City of Brisbane
Subcommittee Report

SUBJECT: Ordinance No. 576 (Zoning Text Amendment RZ-5-11) to Amend Brisbane Municipal Code Title 17 Regarding Garage/Carport Minimum Setbacks and Height Limits in the R Residential Districts, Off-Street Parking Regulations, and Alteration/Expansion of Nonconforming Structures

DATE: For January 16, 2014 Planning Issues Subcommittee Meeting

MINIMUM GARAGE DIMENSIONS VS. HEIGHT LIMIT
CROSS-SECTION

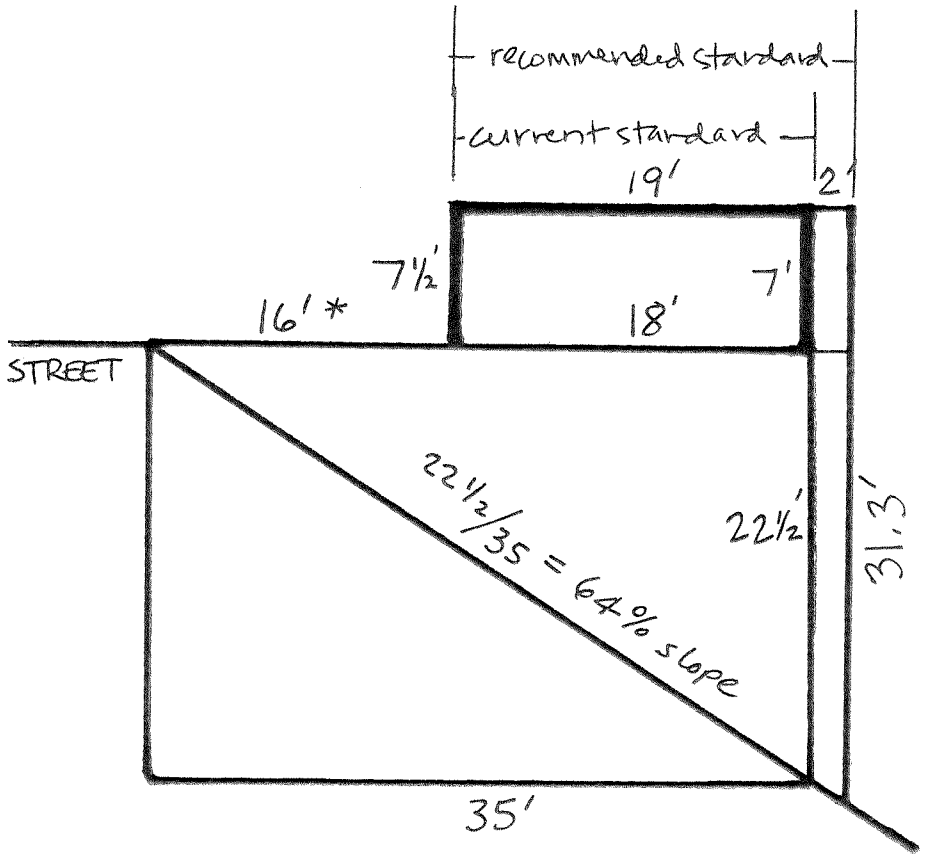
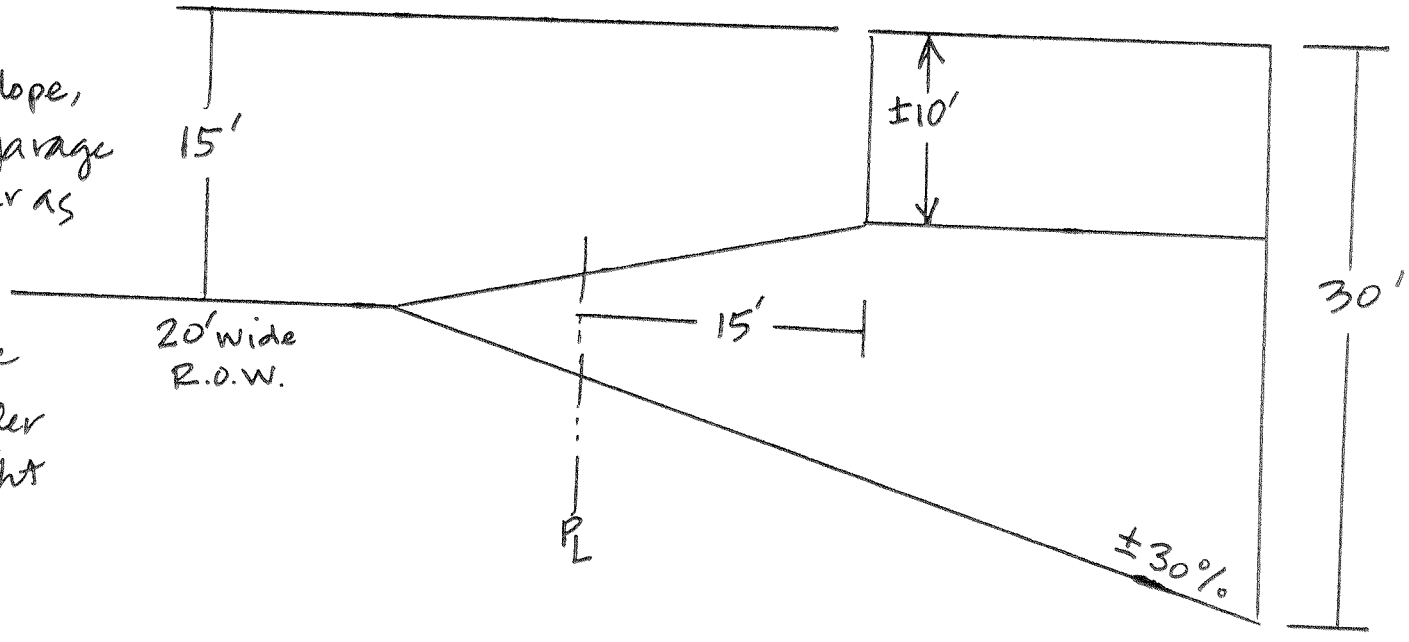
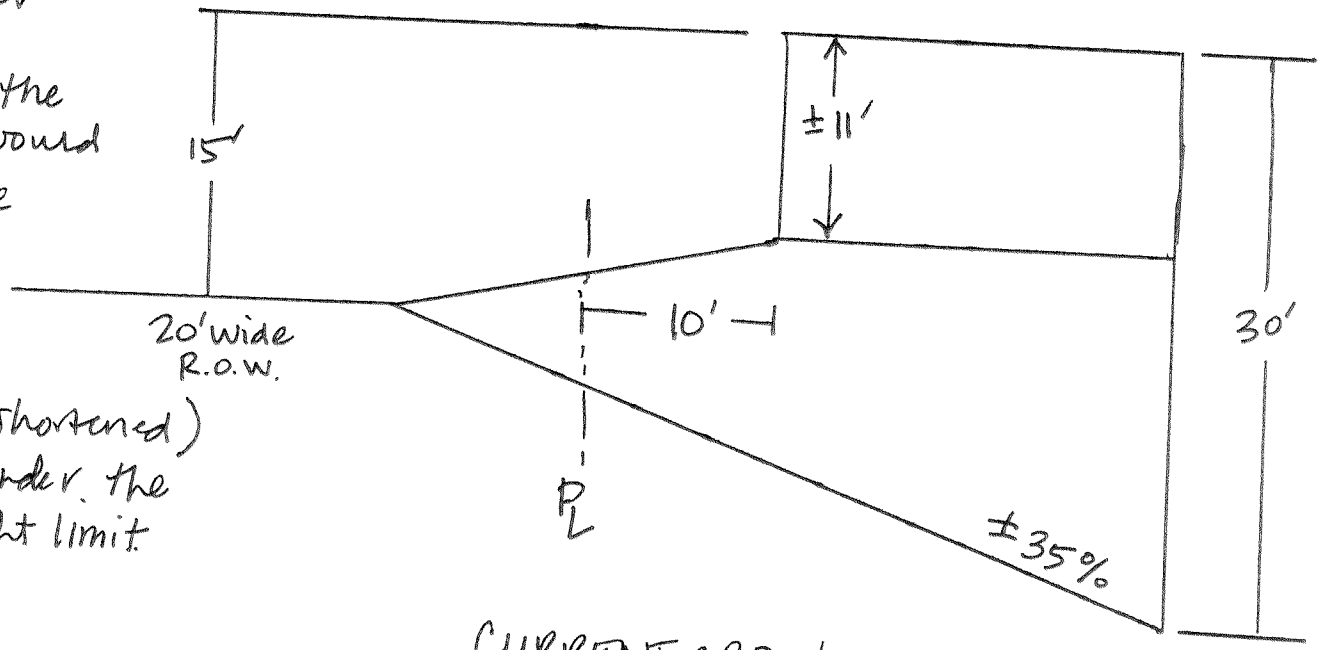
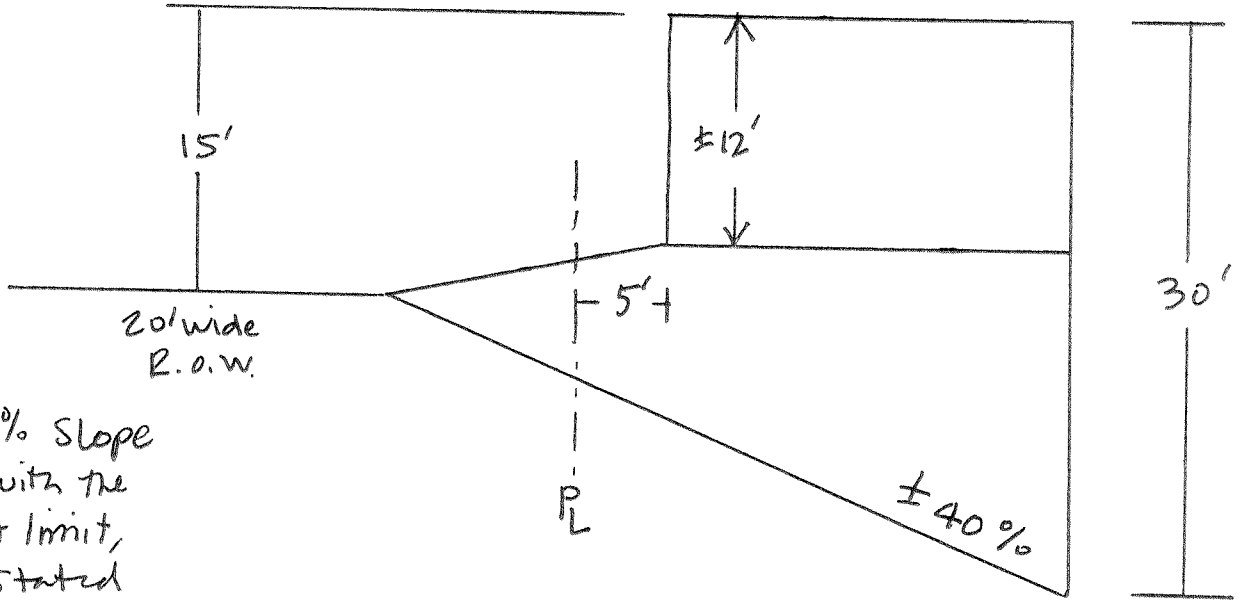
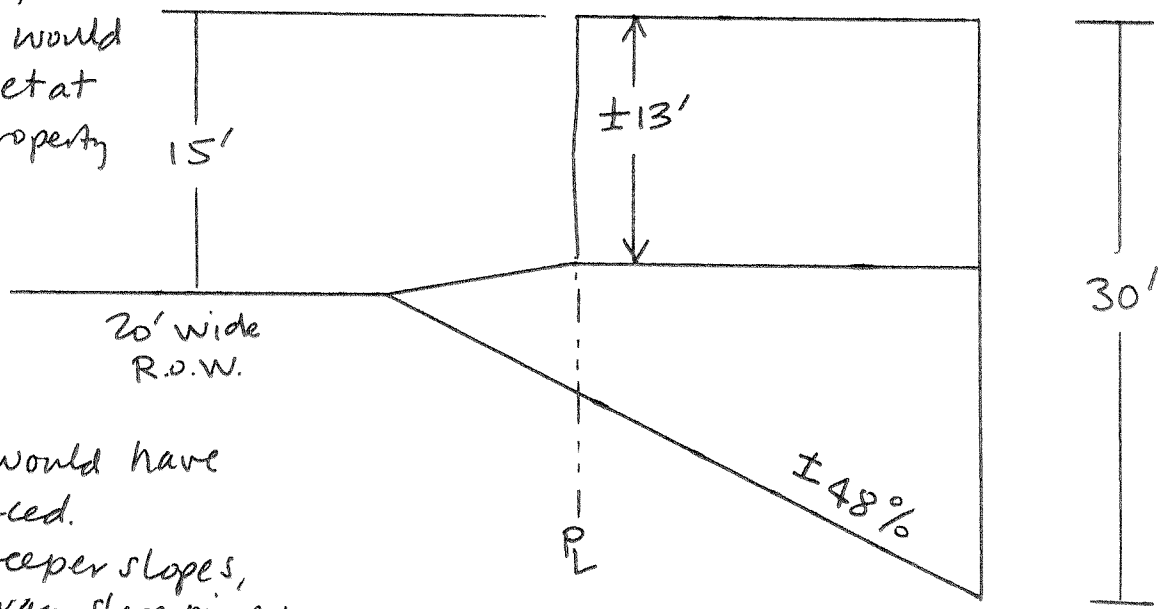
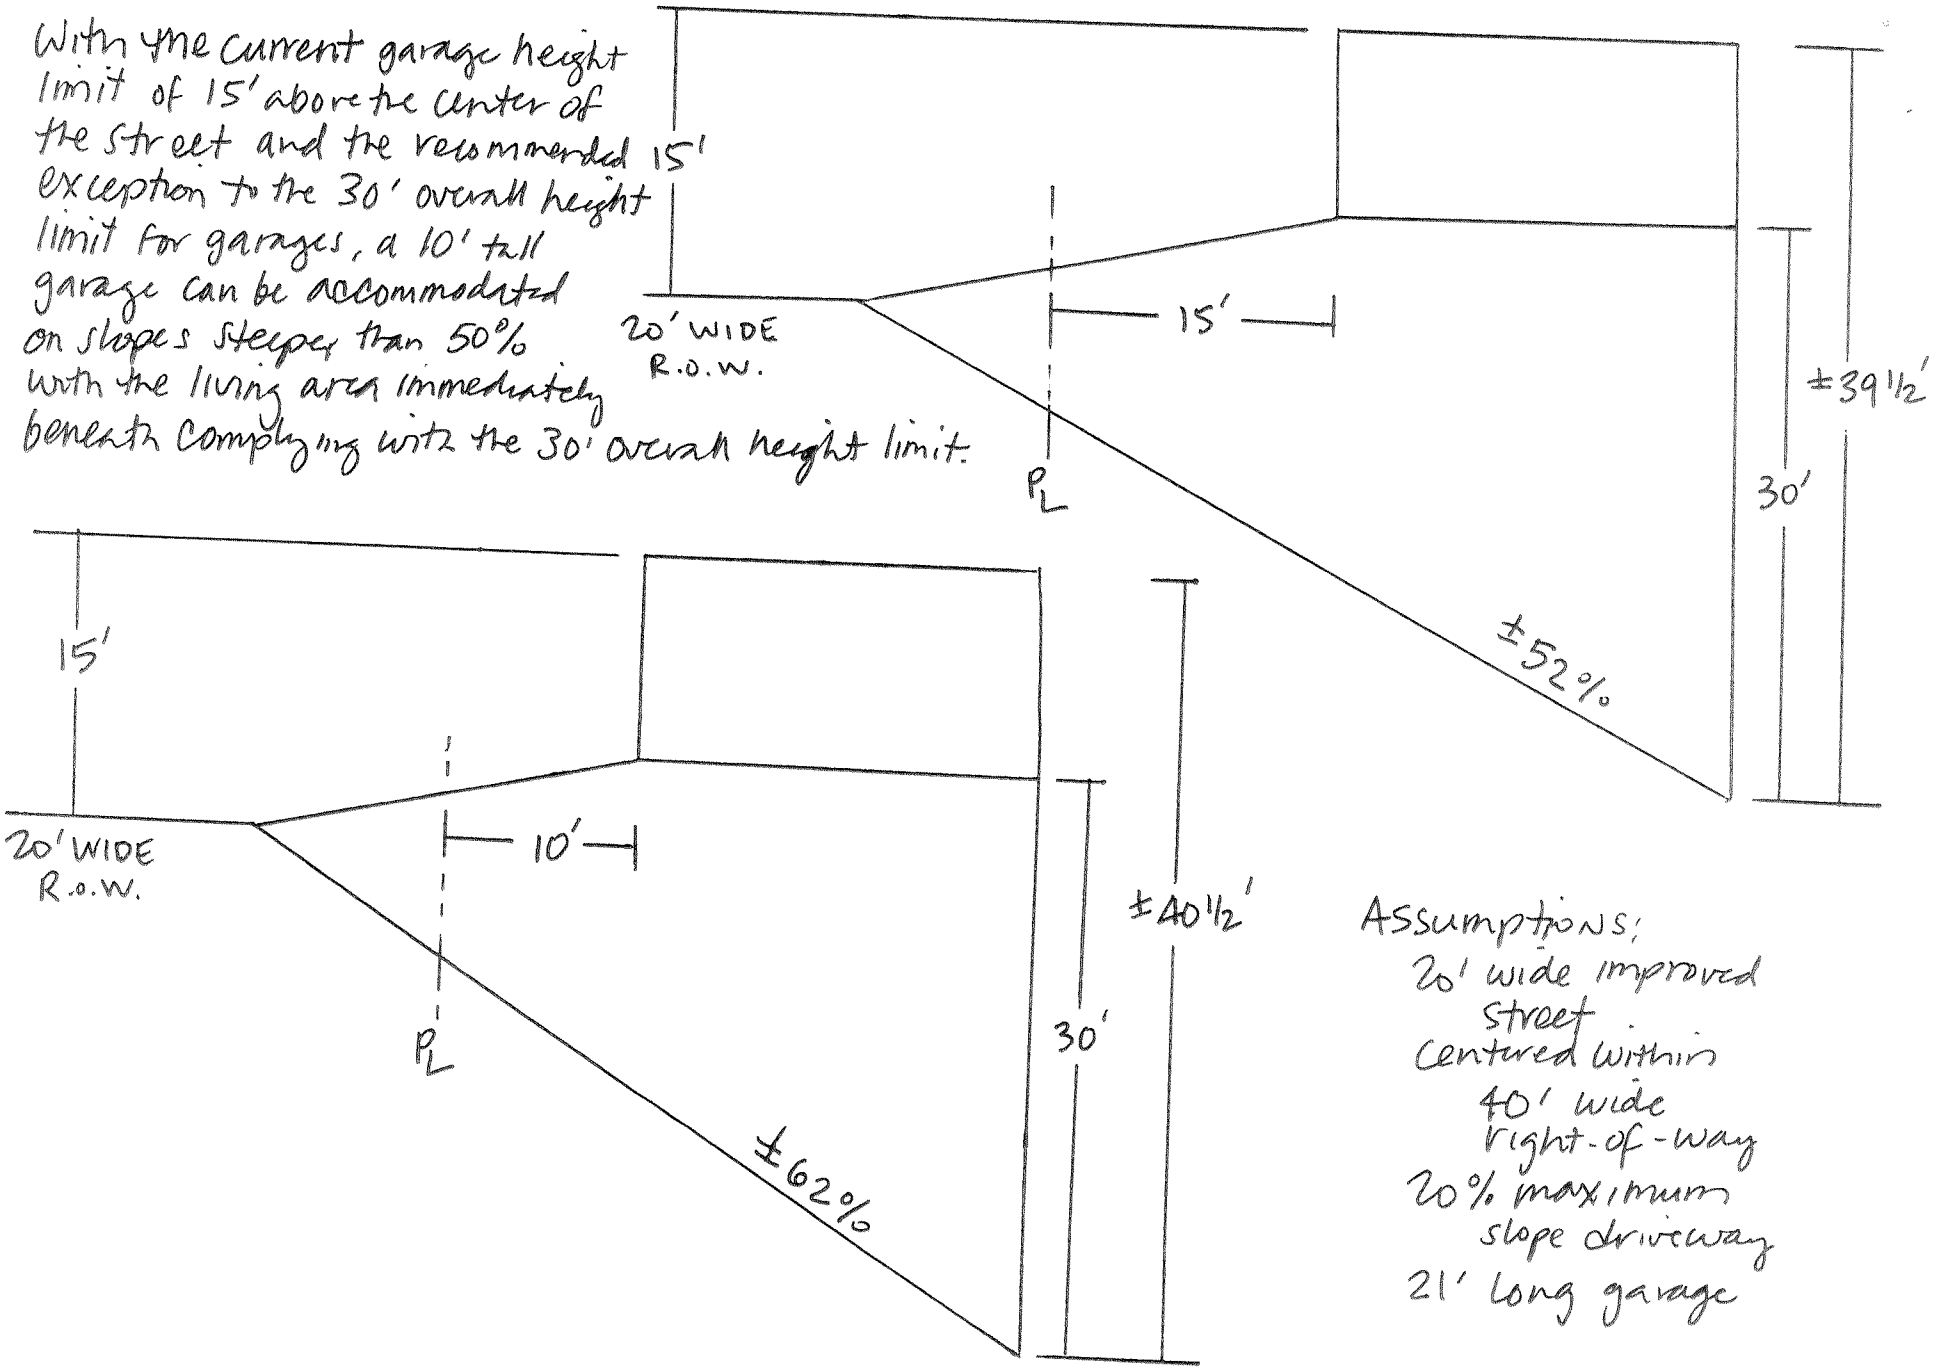
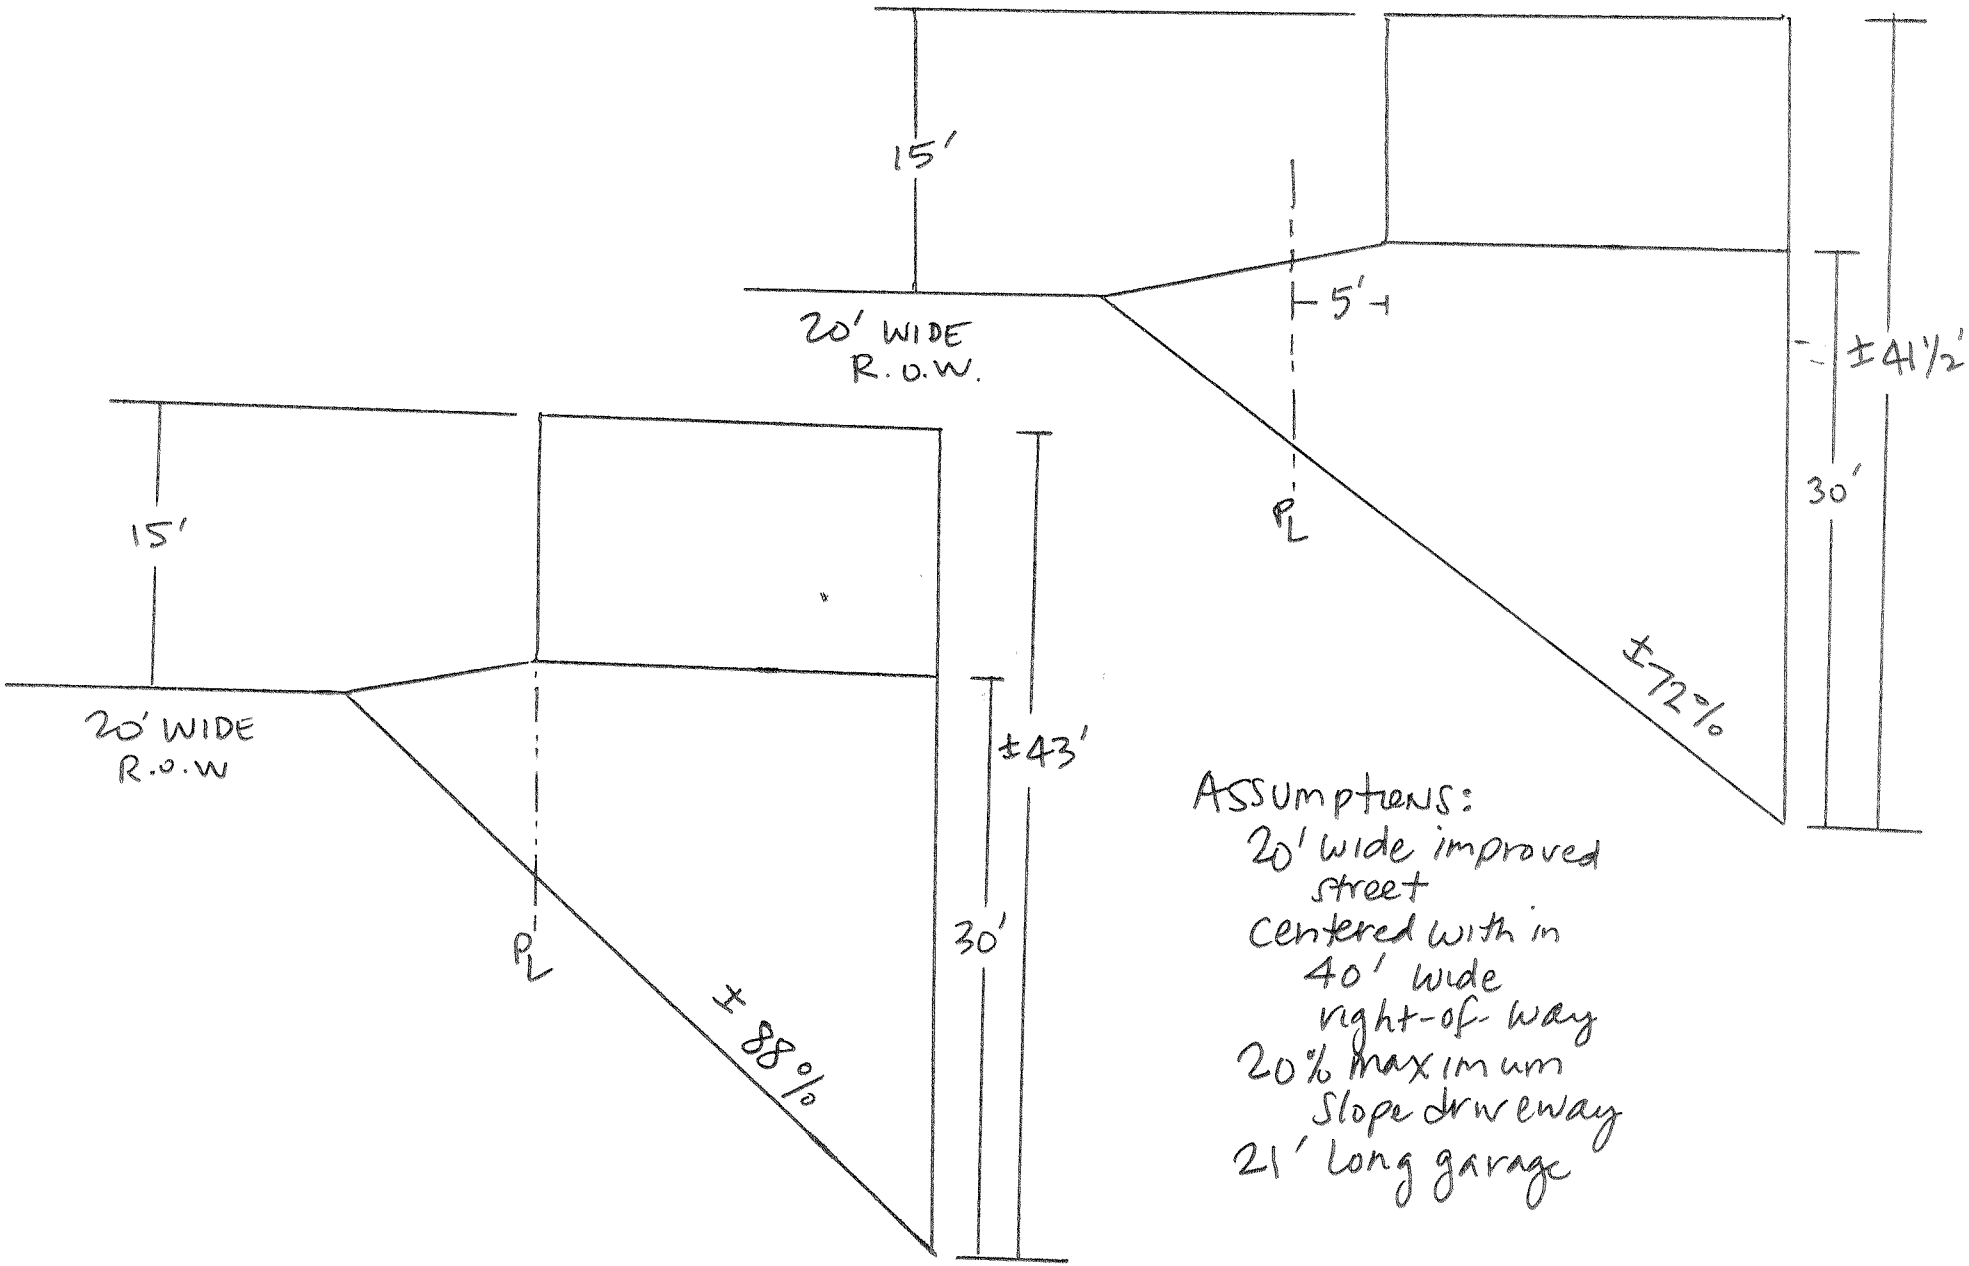
The question was asked that, if the recommended ordinance's requirement that a garage for a new house be 20 ft. deep (instead of the current 18 ft.) would result in additional grading on steep up-slope sites or additional building height on steep down-slope sites, how will the findings required to grant Use Permits to modify the parking regulations (Section 17.34.050.I) work to reduce the 20 ft. minimum interior depth requirement (Section 17.34.040.G.1)?

For example, on a 64% slope, the 2 ft. additional depth required (compared to the current minimum 18 ft. garage space depth) could push the garage over the 30 height limit in the R-1 District (Section 17.06.040.G.1.b), as illustrated on the attached cross-section. The 35 ft. height limit in the R-BA District (Section 17.12.040.G) was intended to accommodate the steeper slopes typically found in the Brisbane Acres.

Under the recommended ordinance, the Planning Commission would be required to make 3 findings in order to grant a Use Permit to reduce the required 20 ft. interior depth for a new garage:

New garages on steep sites where providing the extra depth would be more difficult could be granted a Use Permit to modify the parking regulations, if the Planning Commission were able to make these required findings, specifically that the steep slope is a "site constraint" that would make it unreasonable to require the additional garage depth.
